Wisconsin Department of Transportation CONTRACT MODIFICATION JUSTIFICATION

CONTRACT ID: 20180911005	CONTRACT MODIFICATION NO: 026
PROJECT ID: 2250-12-70	FEDERAL ID: WISC 2018375
HIGHWAY OR LOCAL ROAD: STH 20, STH 83	COUNTY: Racine
PROJECT DESCRIPTION: Main St/1 st St Vil of Waterford; Buena Park Rd to Milw Ave (STH 36)	
MANAGING OFFICE: Jacobs	LOCAL PROGRAM: <input type="checkbox"/>
PRIOR APPROVAL REQUIRED: <input checked="" type="checkbox"/> YES <input type="checkbox"/> NO (If applicable attach additional justification.)	
Attached Contract Modification <input type="checkbox"/> Other Supporting Documentation Attached <input type="checkbox"/>

This is a no cost change order which describes the need to extend the contract completion date due to unforeseen issues occurring from adverse weather, utilities, staging, and other design deficiencies.

STAGE 1

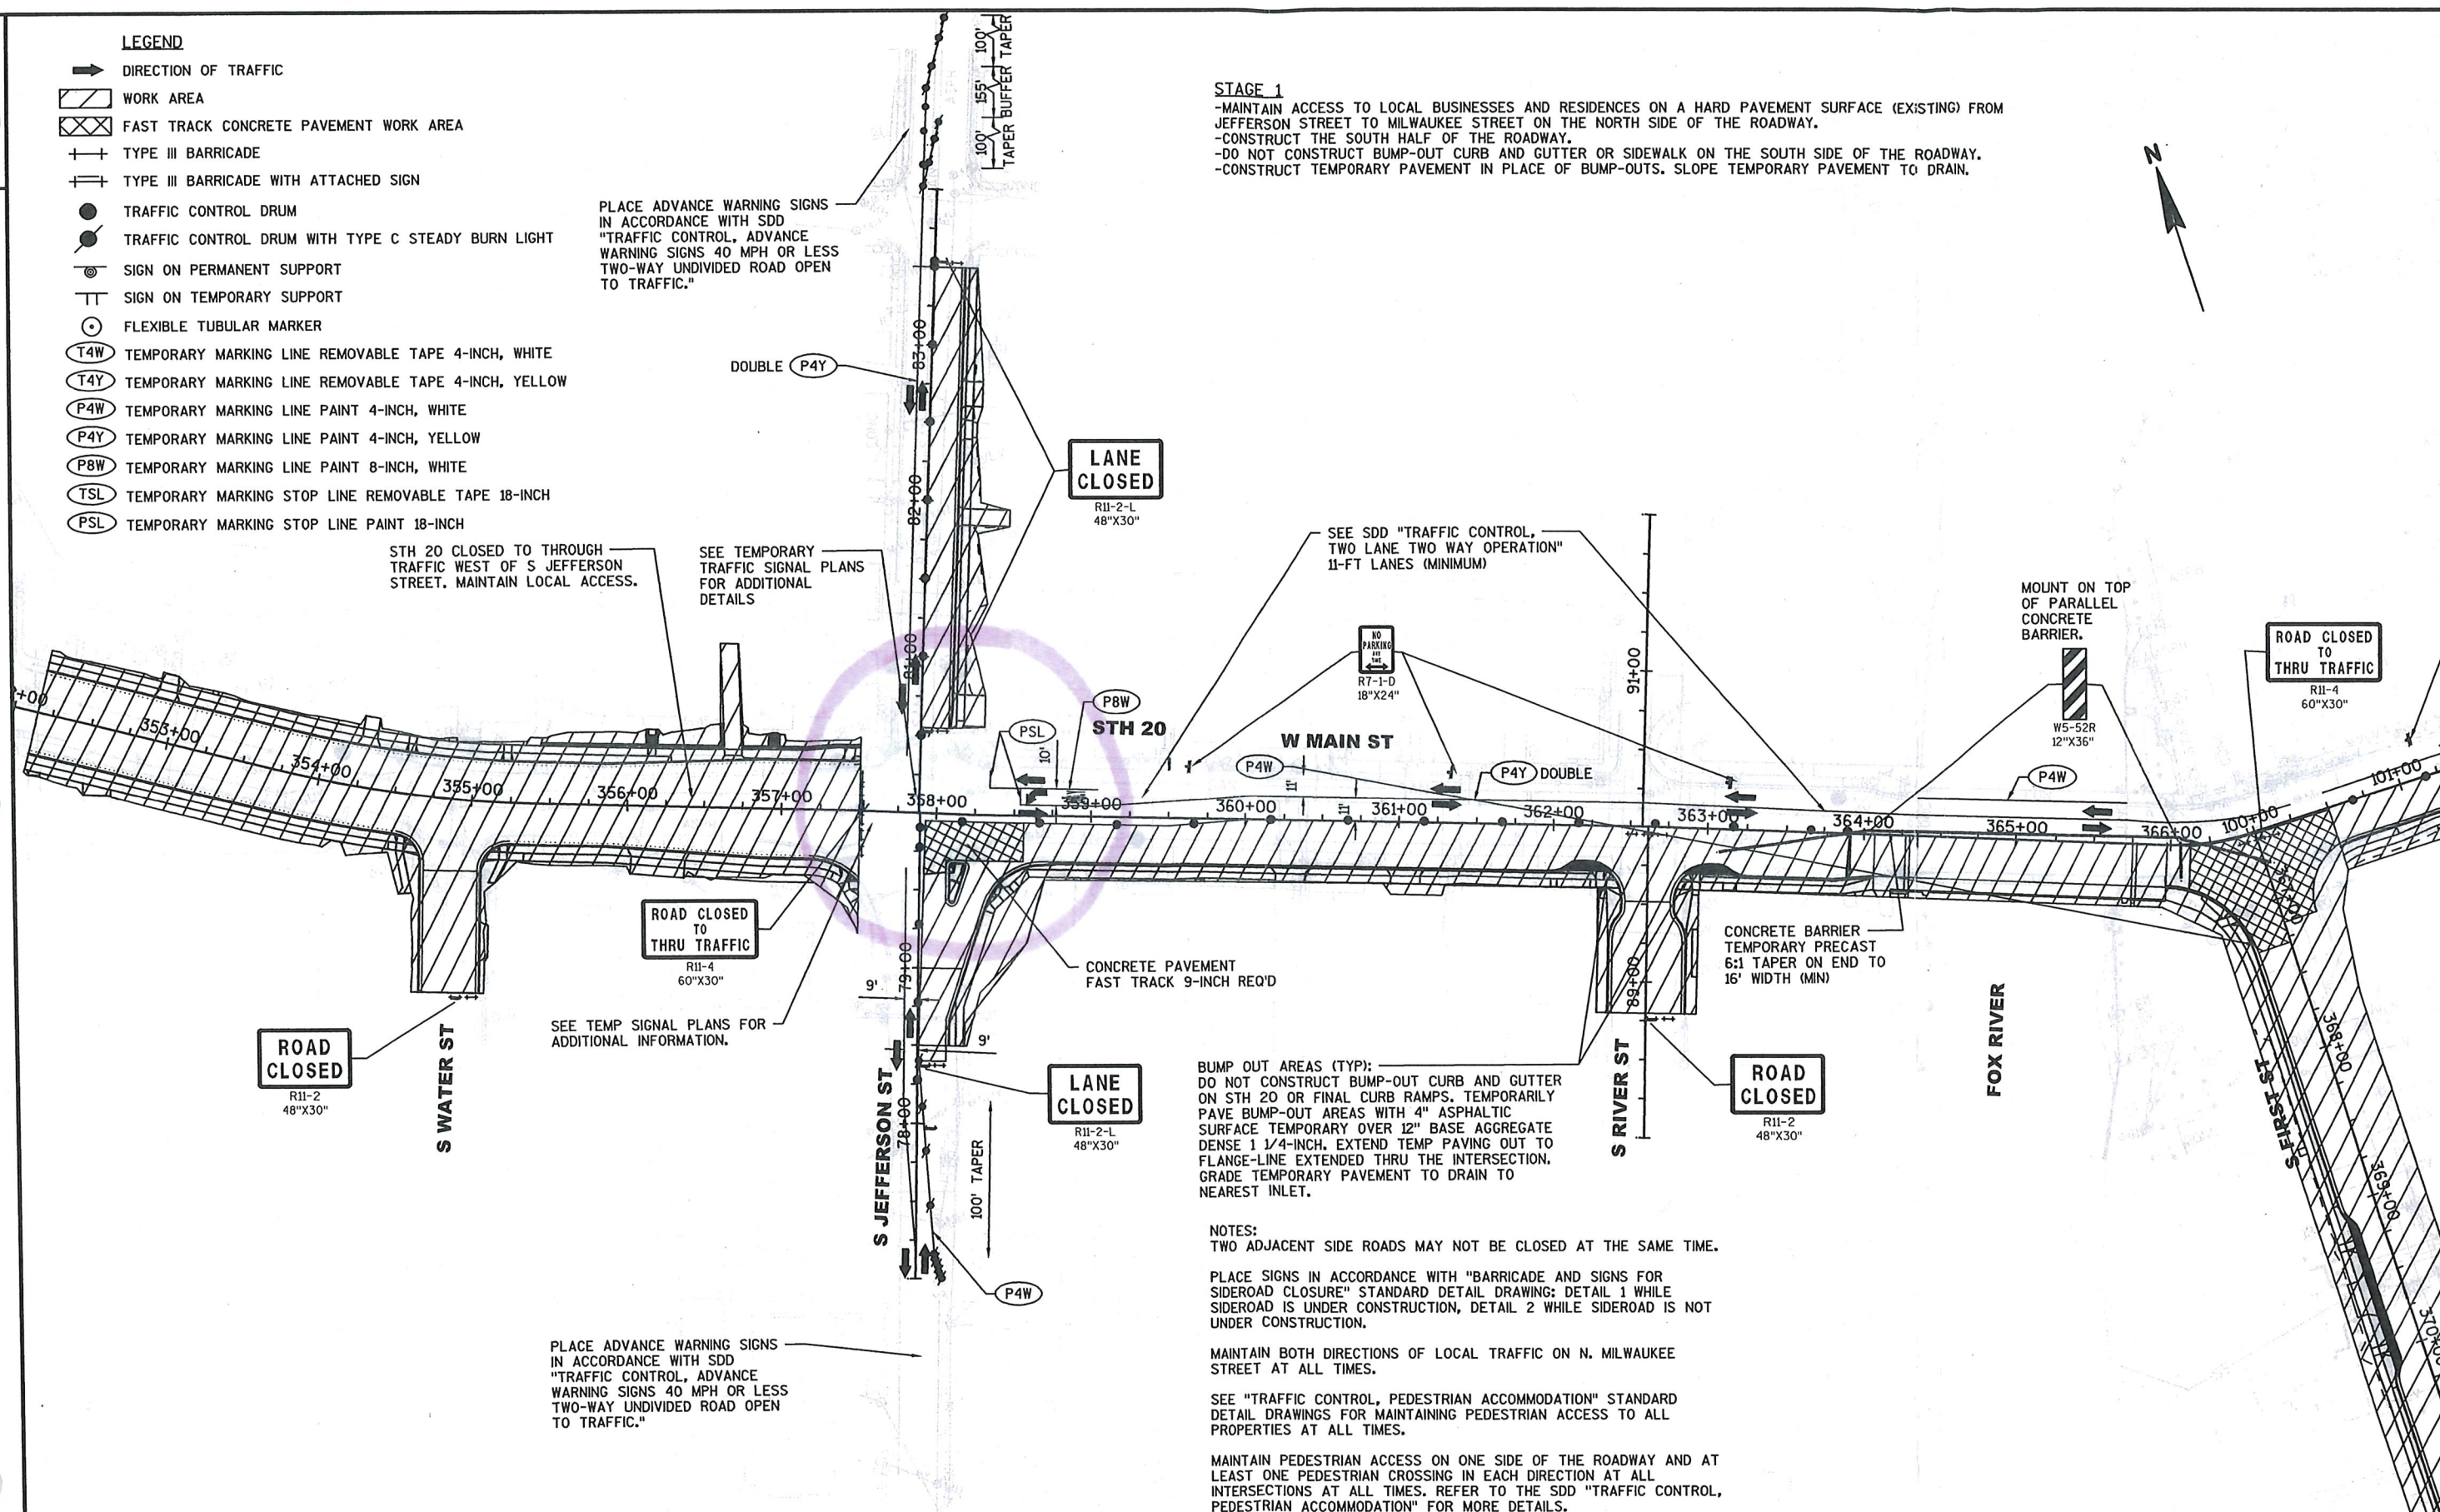
As shown on Sheets 309 and 311, the plan does not include a stage where the northeast corner of Jefferson and Main was to be built. Sheet 311 indicates the use of Fast Track Pavement on the NE quadrant of the intersection, but Sheet 311 also designates north-south through traffic through this same quadrant. Zenith Tech made modifications to the traffic control to allow this quadrant of the intersection to be built, but was adequate time included in the design engineer's estimate of days? Based on our notes, it took 22 days to complete removals, install storm sewer, grade and backfill the corner, install electrical crossings, fine grade, set forms, place concrete, cure time and perform the asphalt tie to the new concrete.

Obviously this was a significant design oversight, but we cannot be held to a completion date when a quarter of a major intersection was omitted from the construction staging plan. As I'm sure you understand, there are numerous contractors involved in the construction of a single quarter of an intersection. As shown below, payment for Fast Track Pavement does not take into account the grading, sewer, electrical and asphalt related work needed to fully open this quadrant of Jefferson Street. Furthermore, due to grade changes within the intersection, asphalt wedging was needed to match the new concrete pavement into the adjacent asphalt pavement. The Fast Track Pavement Special Provision may be applicable on a freeway or rural highway, but it is most certainly not applicable on an urban reconstruction project with multiple utility installations included in the contract. It is requested that 22 days be added to the contract to cover the actual amount of time it took to build this quadrant of the intersection and switch traffic on Jefferson Street.

Plan sheets 309 and 311 do not include a stage where the northeast corner of Jefferson and Main Street was to be built. Sheet 311 indicates the use of Fast Track Concrete Pavement to construct the NE quadrant, but it also conveys to put north/south Jefferson Street traffic through this same quadrant. The contractor made modifications to the traffic control to allow this quadrant of the intersection to be built. The Fast Track Concrete Pavement item was replaced with item SPV.0108.01 Concrete Pavement 9-Inch SHES through contract mod #13. The item kept the some of the specification language for the Fast Track Concrete Pavement. The payment terms do not include the work for grading, storm sewer, electrical and asphaltic pavement needed to fully open this quadrant of Jefferson Street. The contractor is owed additional time to complete removals, install storm sewer, grade and backfill the corner, install electrical crossings, fine grade, set forms, place concrete, cure time, and perform the asphalt tie in to the new concrete. **The contractor is excused 22 working days.**

Staging Issue:

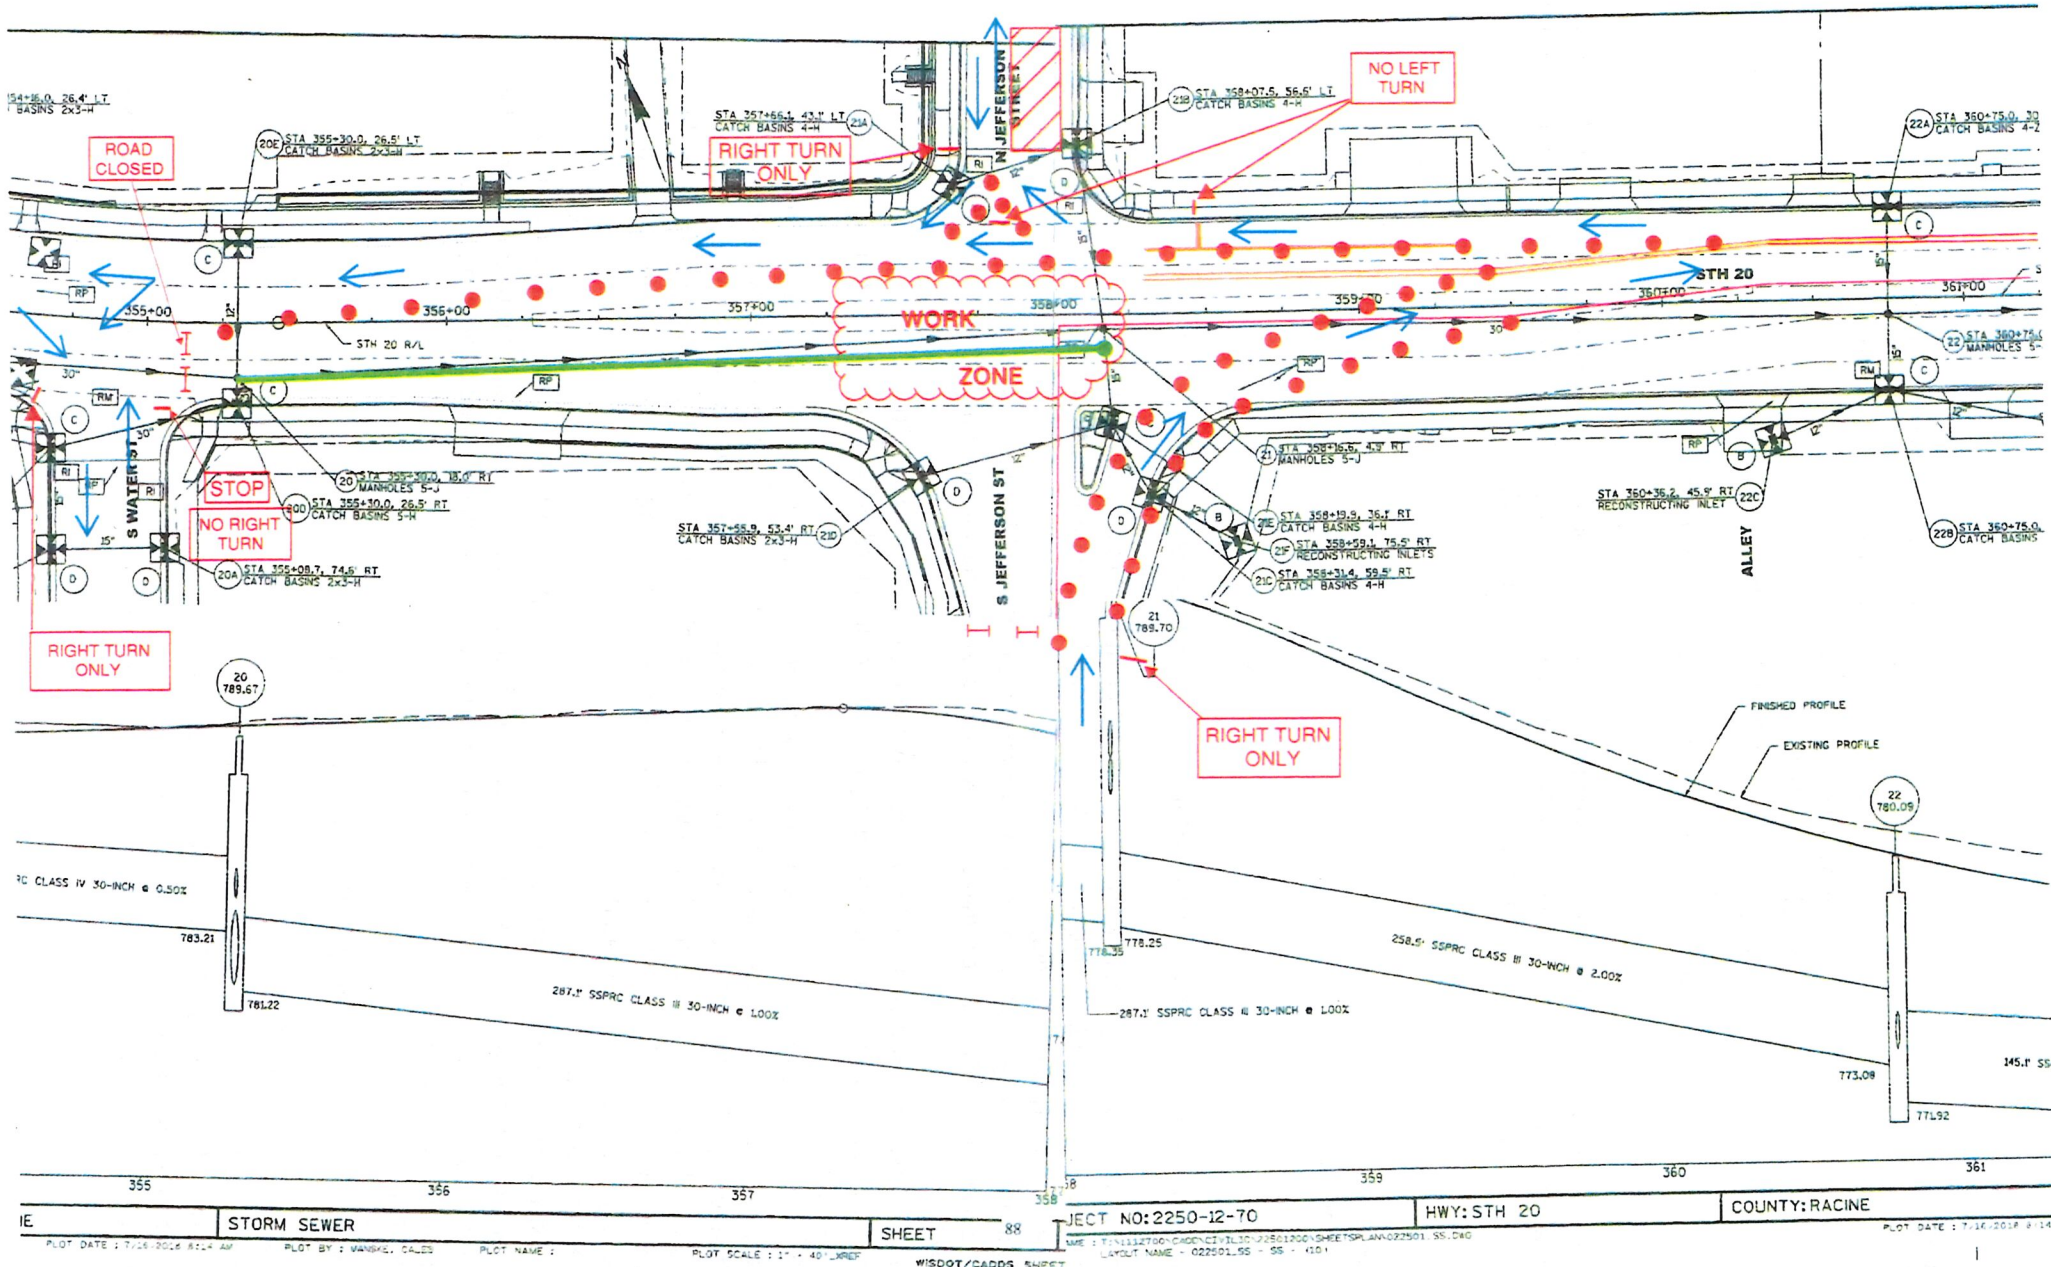
Similar to Buena Park, but of even greater overall impact to the project and personal safety was the installation of the trunkline storm sewer from MH 20 to MH 21 through the Jefferson intersection. This installation was critical as it allowed the new sewer installations west of Jefferson to drain through the new system at full capacity. The need to install this sewer in advance of the other stages of the Jefferson intersection construction was due to the overall depth of the storm sewer run (15' below ground surface) and the extremely narrow lane width (below MUTCD standards) traffic was forced, per plan, to use on Jefferson Street. In truth, there was no conceivable way to safely install the storm sewer to the staging line on Jefferson, at a depth of 15' b.g.s., backfill the trench, move traffic over and resume the same deep immediately adjacent to live traffic. There just wouldn't be enough room to work adjacent to traffic and the trench backfill would invariably slump and undermine the already too narrow lanes on Jefferson Street.

Foreseeing the problem at hand, Zenith Tech developed a one-day traffic control staging plan for the Jefferson intersection and submitted it for the project staff to review. After a few tweaks and modifications, the plan was approved for use. Similar to Buena Park, the hang up on the intersection was over pricing for asphalt patching of the narrow trench through the intersection. Zenith Tech proposed asphalt millings, but the project staff wanted asphalt patching at the same price as Buena Park. The trouble was the low quantity and the demand by the project staff that the trench be patched immediately upon completion and before the roadway opened to its normal traffic pattern. These demands and the uncertainty of the timing caused the asphalt price to soar.

Numerous hours were lost by several sub-contractors on May 20th and compensation for the standby time has not been sought, but the time lost should be made up. We had an acceptable traffic control plan and we were contractually within our rights to use a temporary gravel surface to backfill the trench. In the end, the work ended up being performed on May 21st so only 1 additional day is requested for this operation.

Maintaining Drainage at Jefferson Street: During storm sewer installation and adhering to the contract requirements of Article 13 Maintaining Drainage it was elected by the contractor and approval by the department to add additional traffic control staging through the Jefferson and Main Street Intersection to continue installation of the trunk line storm sewer. The contract plans showed making the connection of trunk line through Jefferson/Main in a future stage which would create a drainage issue by having water store in the trunk line pipe with no way for it to drain until the final connection was made. The added staging allowed the new trunk line to become live and maintain drainage. Contract Mod #14 compensated the contractor for the extra traffic control staging but did not address contract time affecting the controlling item of storm sewer. The added time accounts for implementing the additional traffic control and patching the trench through the intersection back with asphalt. **The contractor is excused 1 working day.**
